### ADDENDUM NO. 1 - OUTLINE AND SUMMARY INFORMATION

Project Name: MSU Stadium Lots

PPA No.: 22-0012

Date: 03-27-2024

SHEET  
**CU1.7**

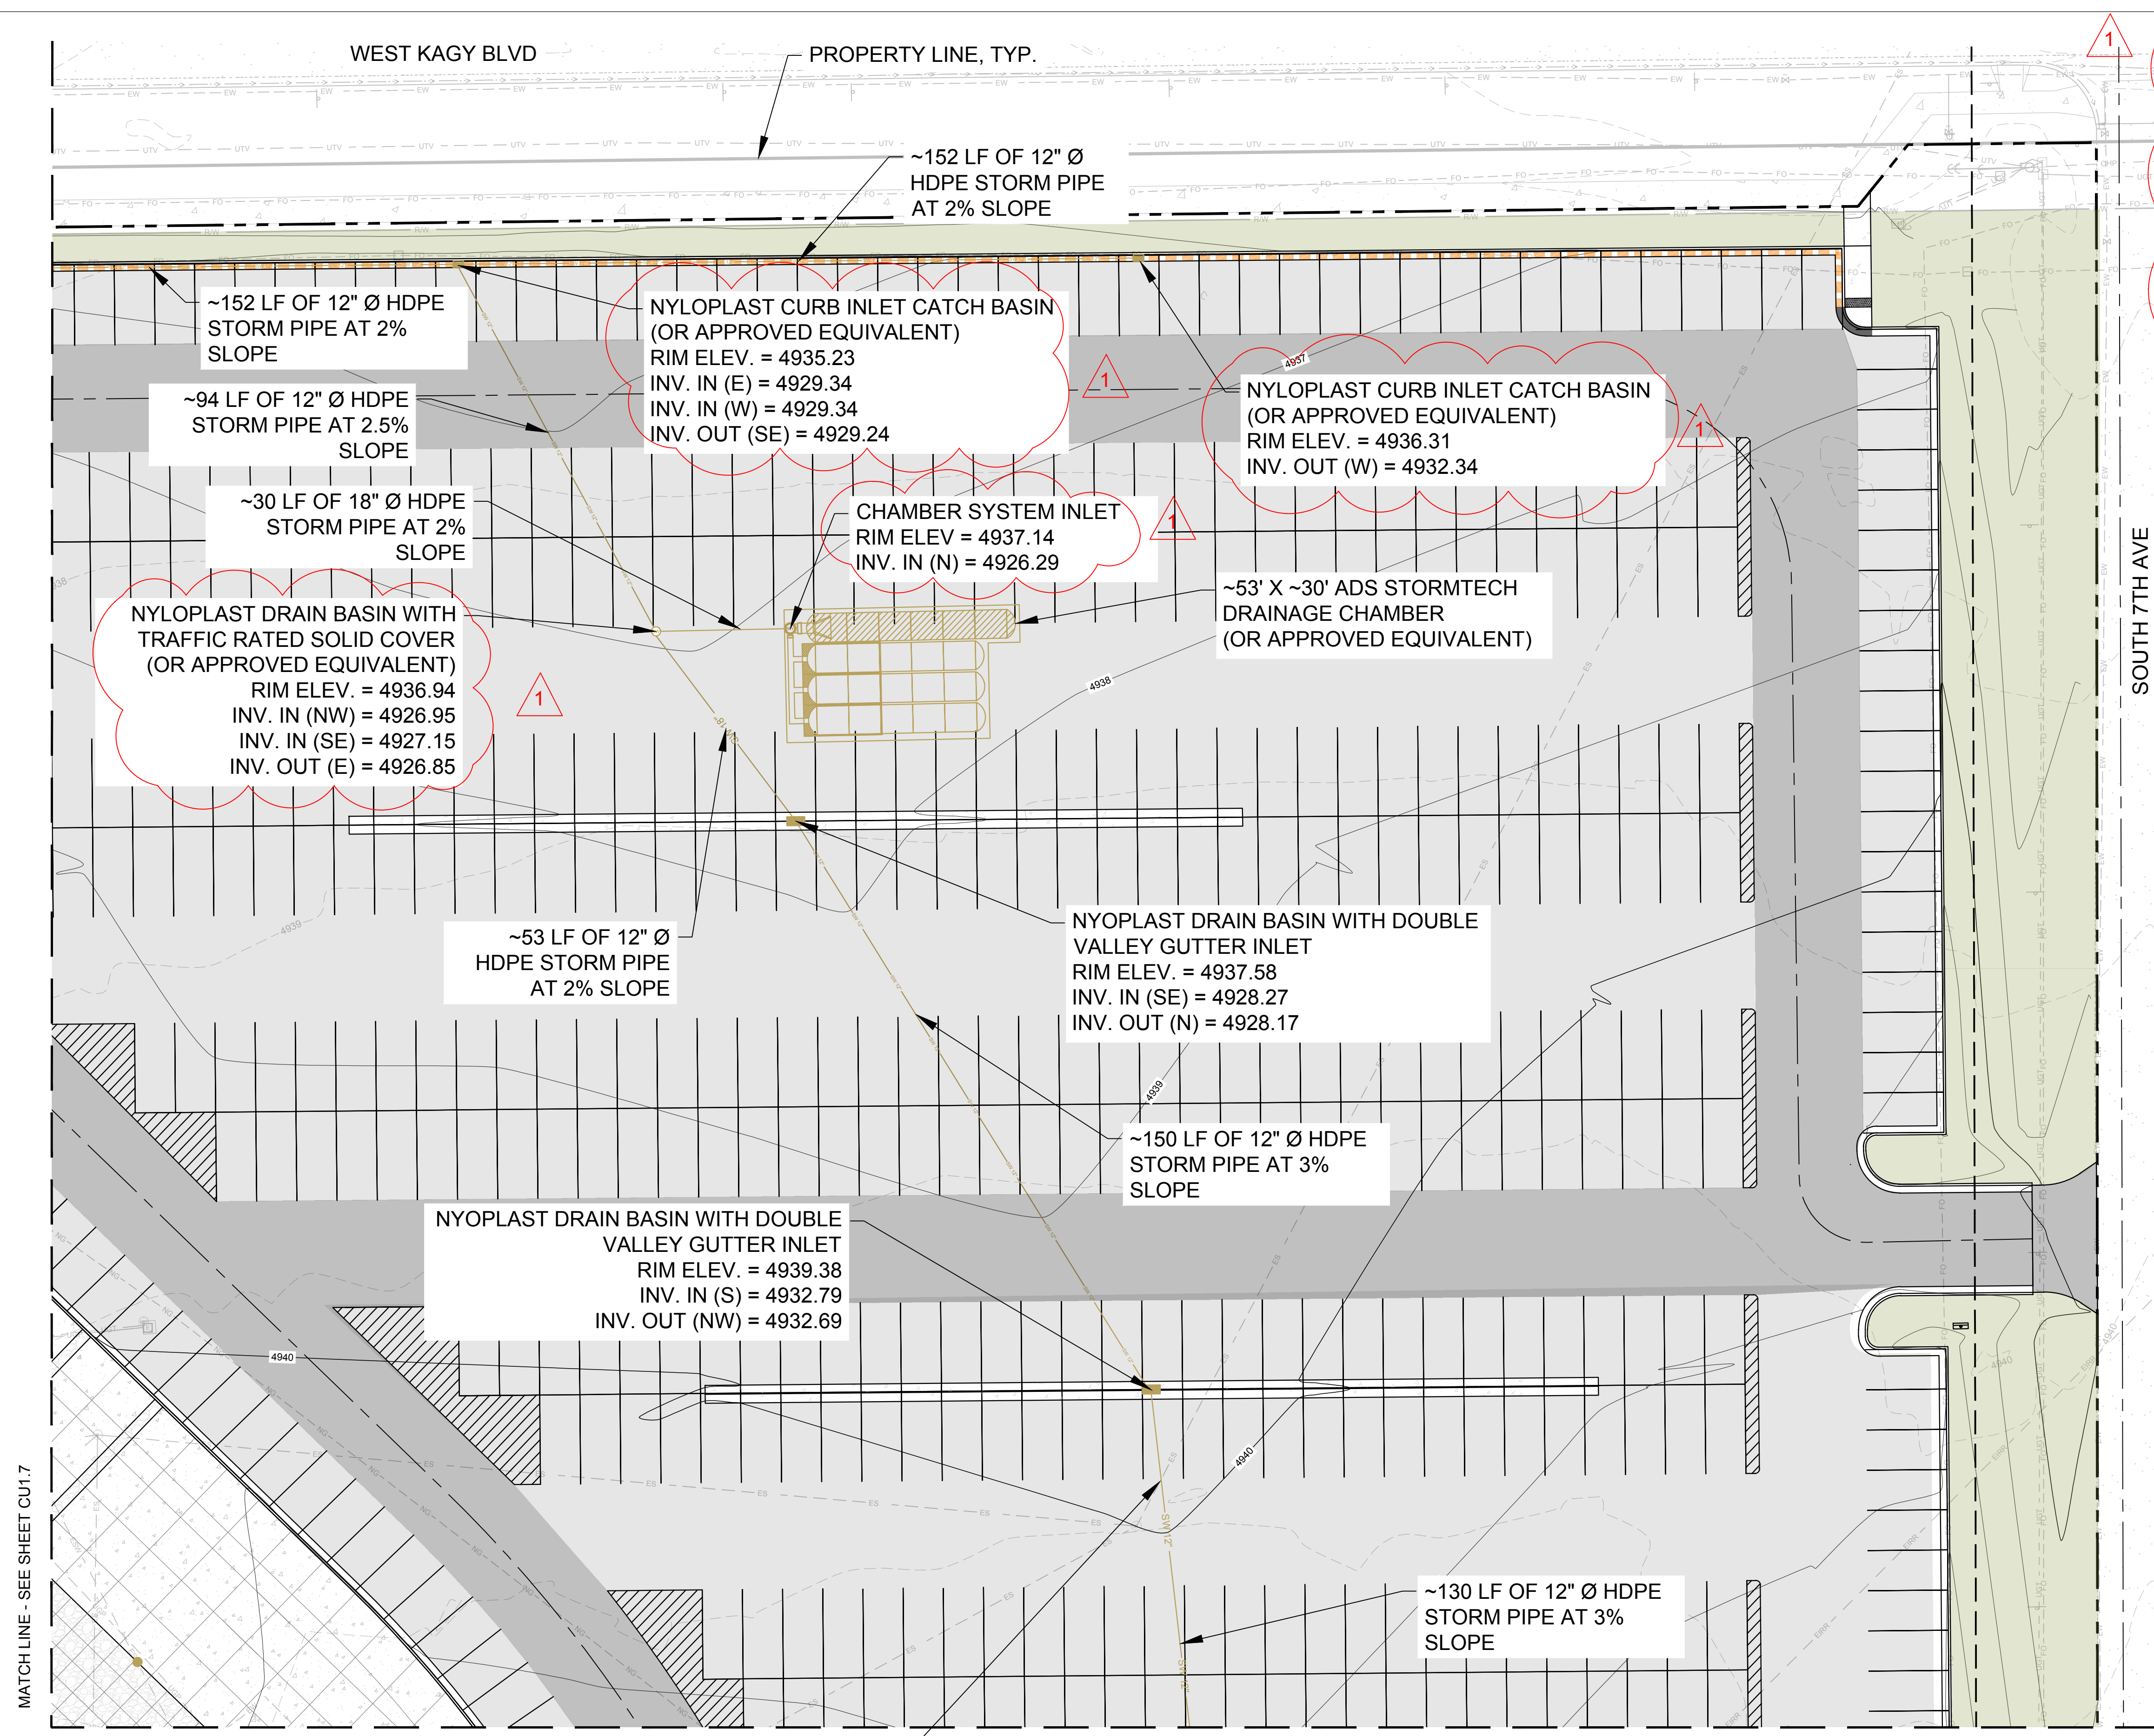
- B. REVISE – STORM INLET INVERTS: The two storm drainage inverts along the north curb were raised on this sheet to lessen the cost of trenching/excavation.

SHEET  
**CU1.8**

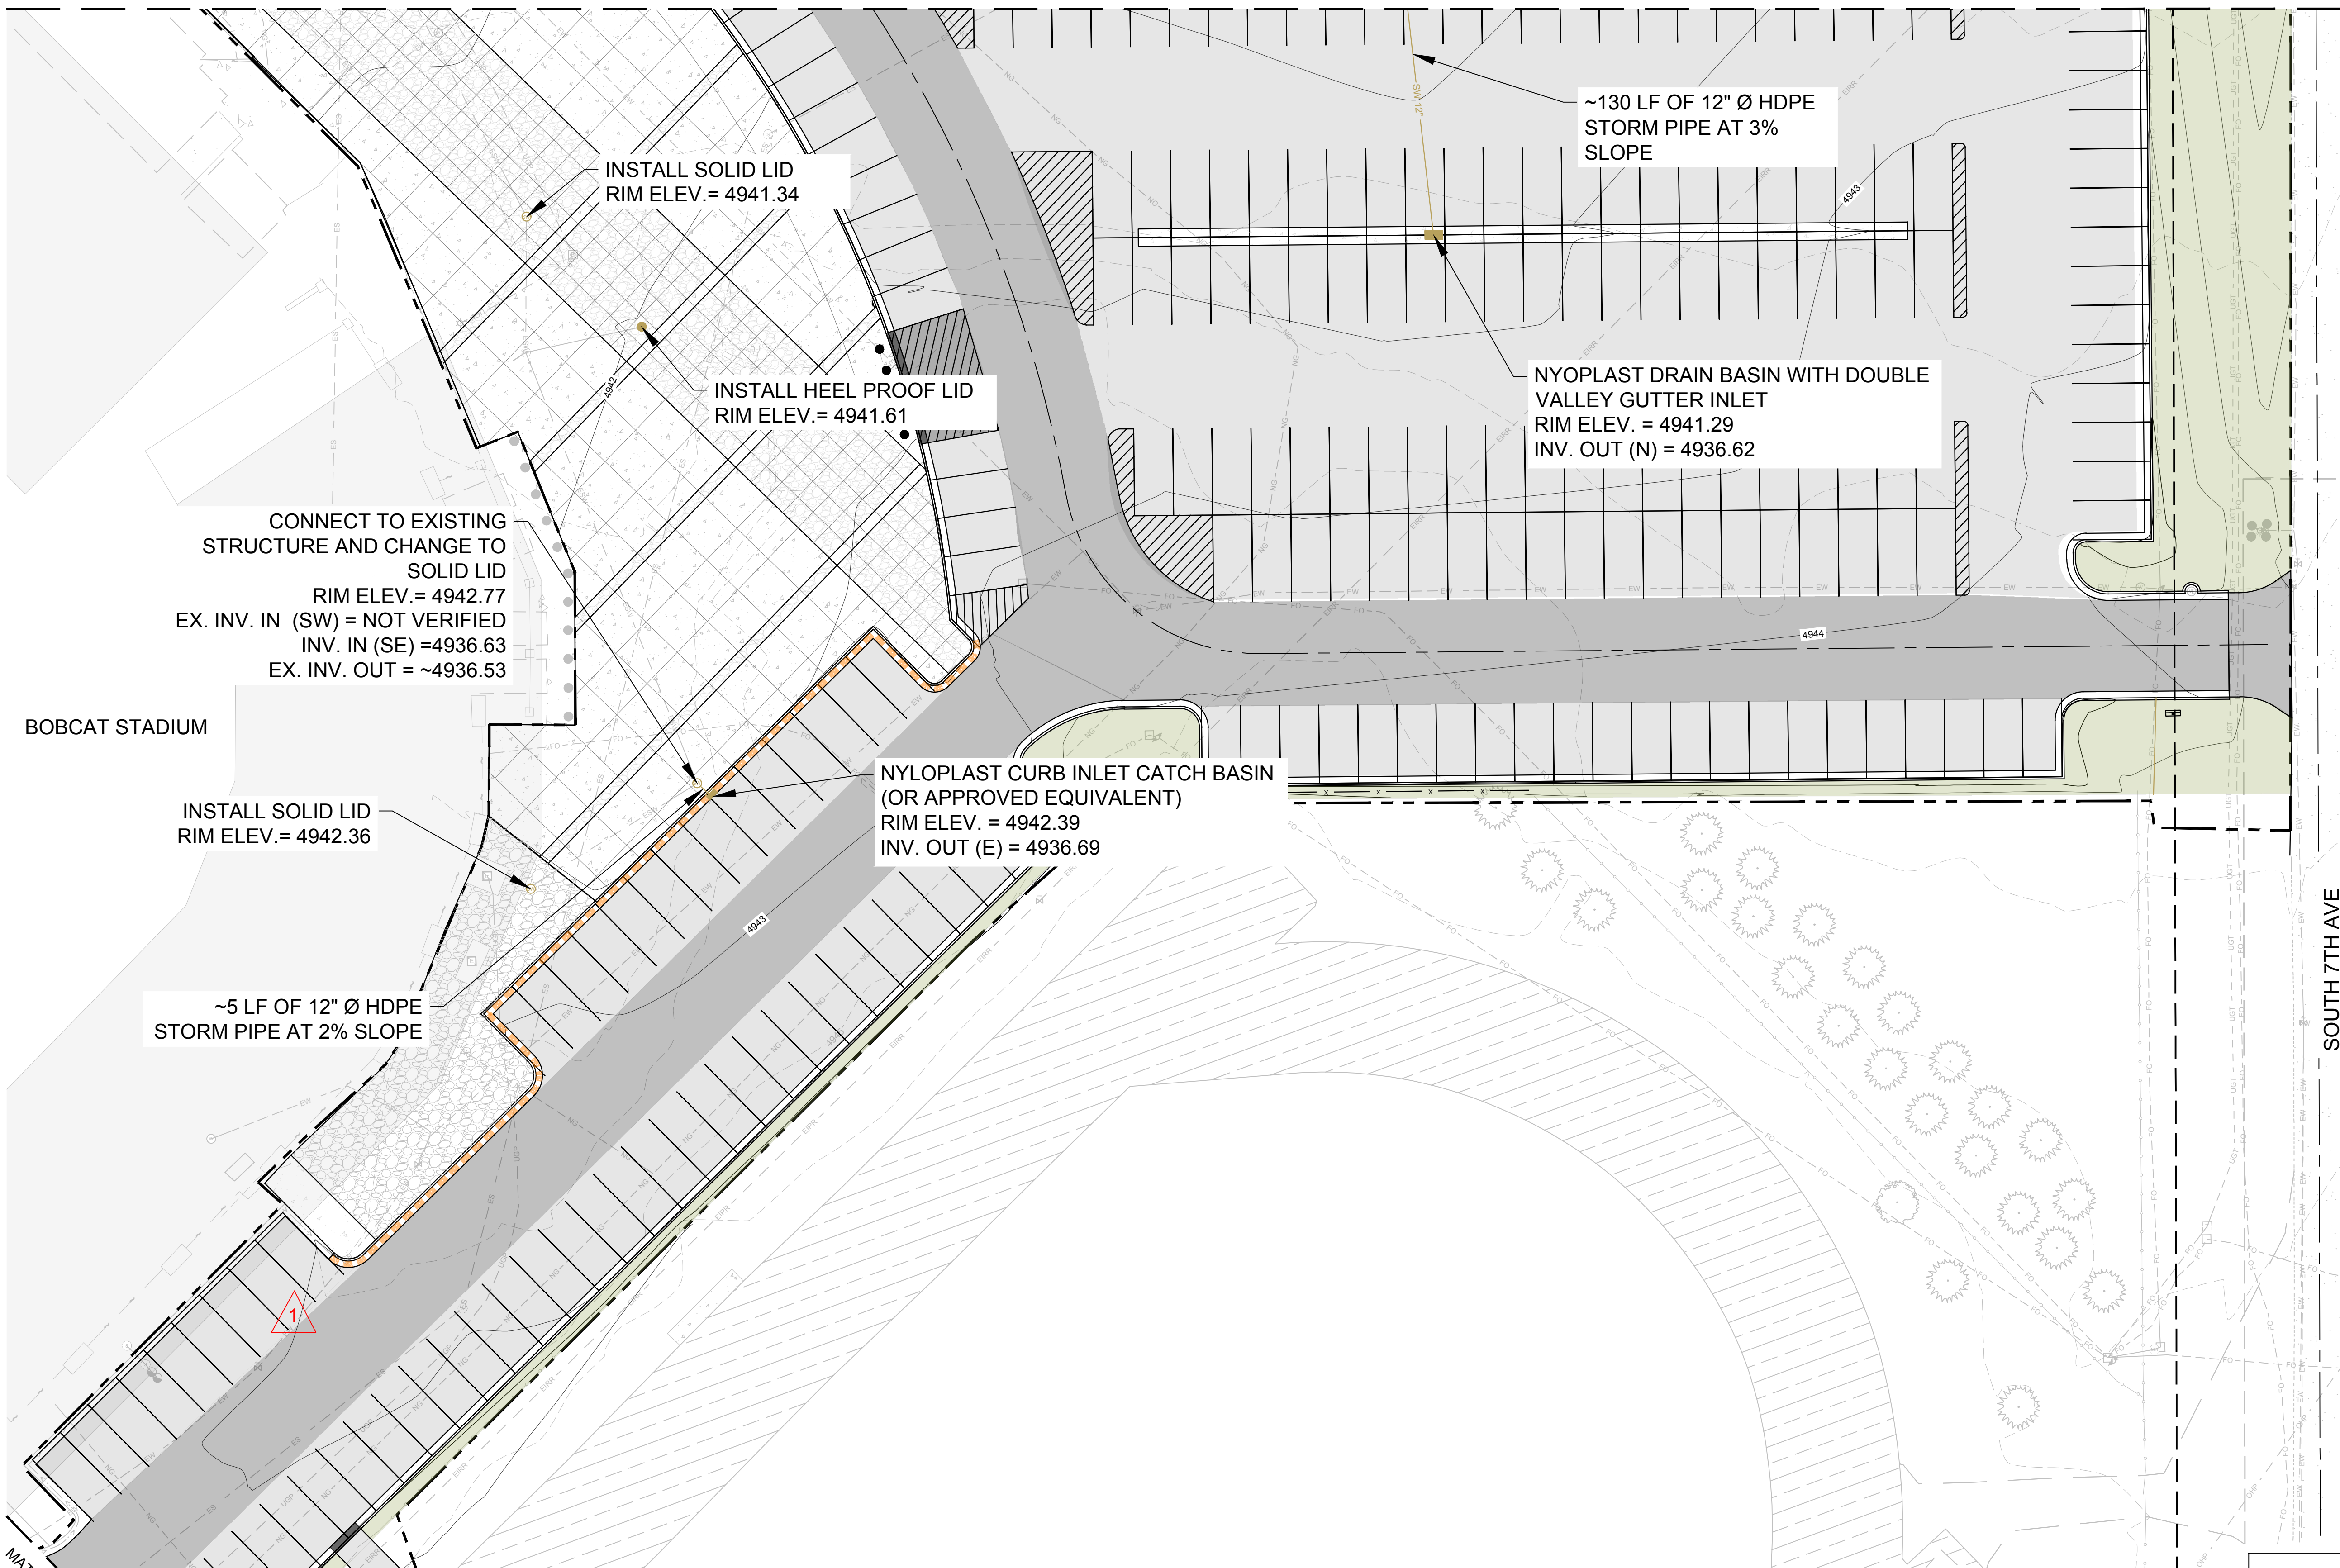
- A. ADD - GENERAL NOTE: General note #9 was added to provide the contractor with further clarification on tying into existing storm infrastructure.
- B. REVISE – STORM INLET INVERTS: The four northern most storm drainage inverts were raised on this sheet to lessen the cost of trenching/excavation.

DETAIL 10

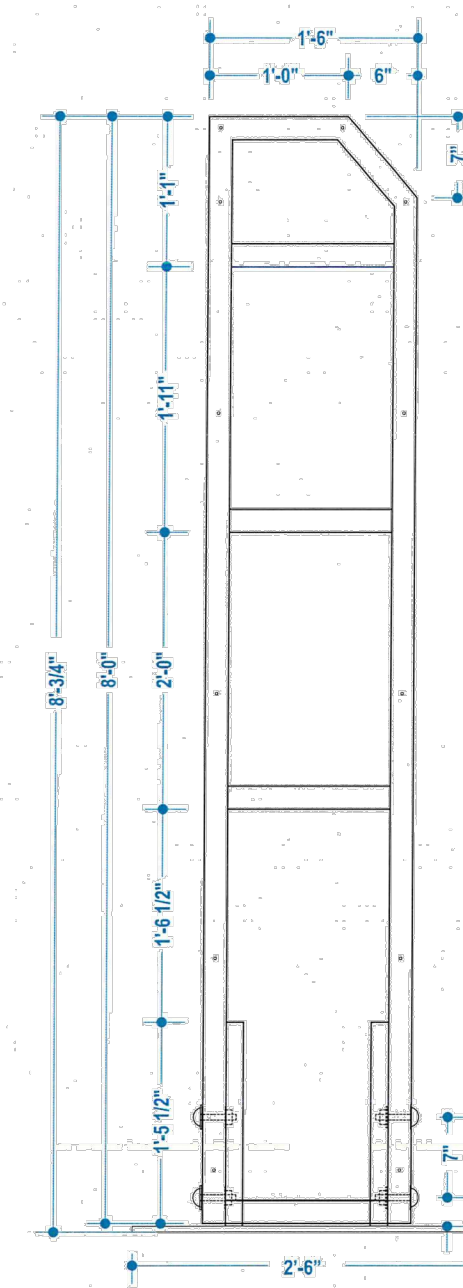
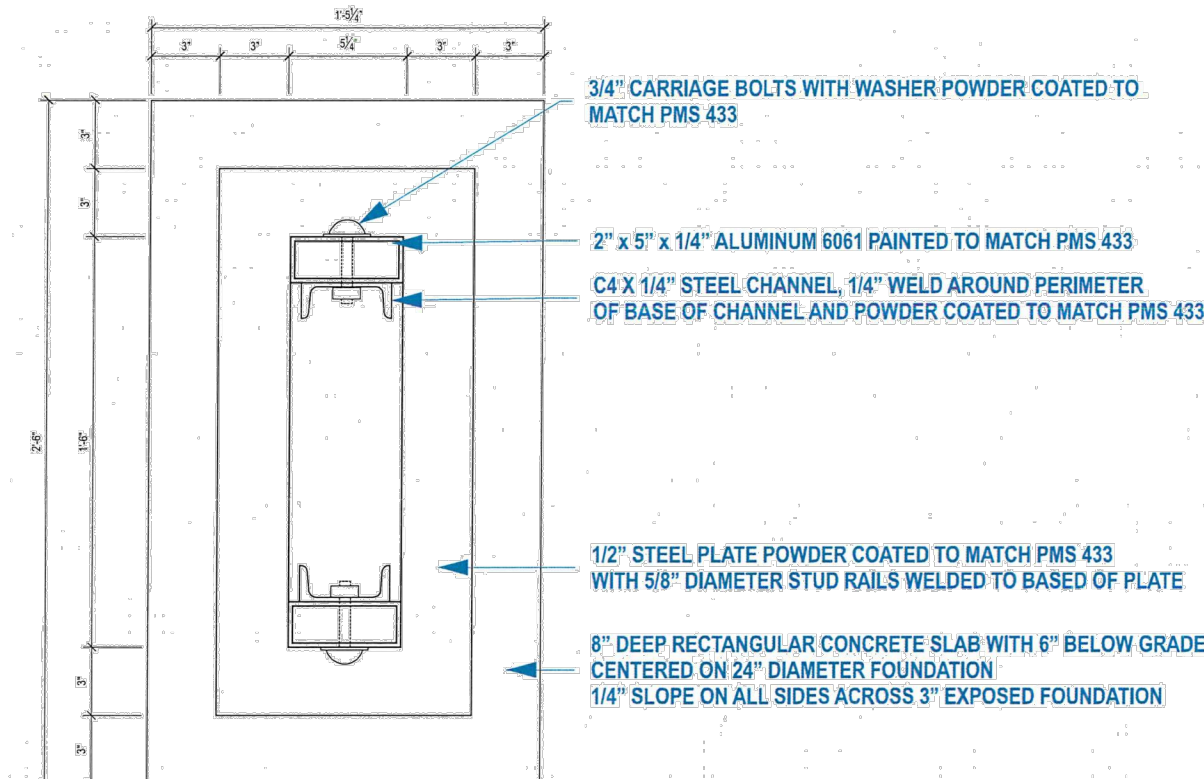
- A. REVISE – MONUMENT SIGN QUANTITY: The quantity of 51 monument signs has been removed, as there are only four monument signs to be installed.

SHEET  
**LI2.0**

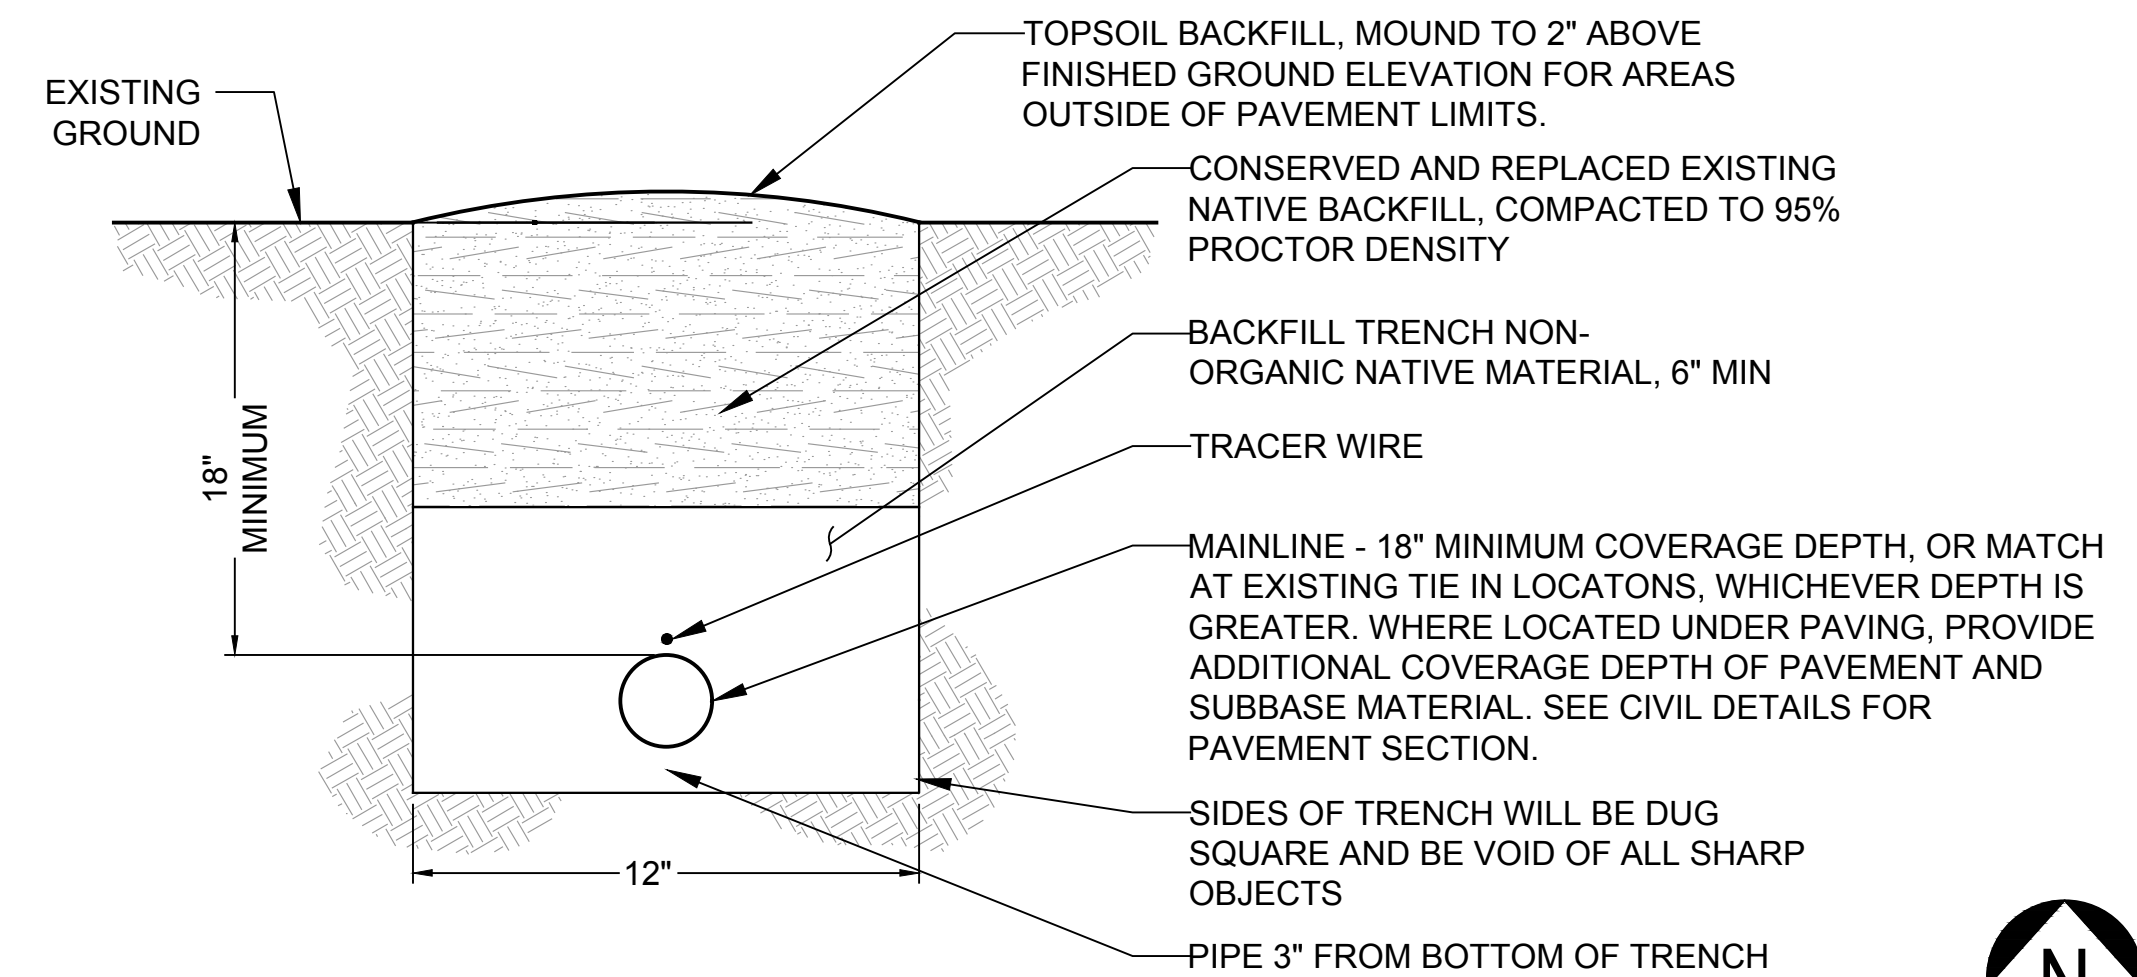
- A. REVISE – ISOLATION VALVE PRODUCT CALLOUT: The callout associated with the 16” isolation valve located on the 16” irrigation mainline has been updated to include basis of design product information for type of valve to match in-kind with Owner provided item. Product cut sheet information may be requested from Owner by awarded contractor following awarding of the project.

1  
 INSTALL NEW 16" ISOLATION VALVE DOWNSTREAM OF EXISTING VALVE ON HDPE MAINLINE. CONTRACTOR SHALL USE OWNER PROVIDED VALVE FOR INSTALLATION AND PROVIDE REPLACEMENT TO OWNER SHELF STOCK WITH IN-KIND VALVE AS PART OF THIS PROJECT. ISOLATION VALVE SHALL BE MUELLER LINESEAL III BUTTERFLY VALVE 3211-6 FLANGED ENDS CLASS 125, 16-INCH SIZE, WITH STANDARD BURIED SERVICE ACTUATOR MDT-3S, OR APPROVED EQUAL. ISOLATION VALVE LOCOTON TO BE DETERMINED IN COORDINATION WITH THE OWNER.
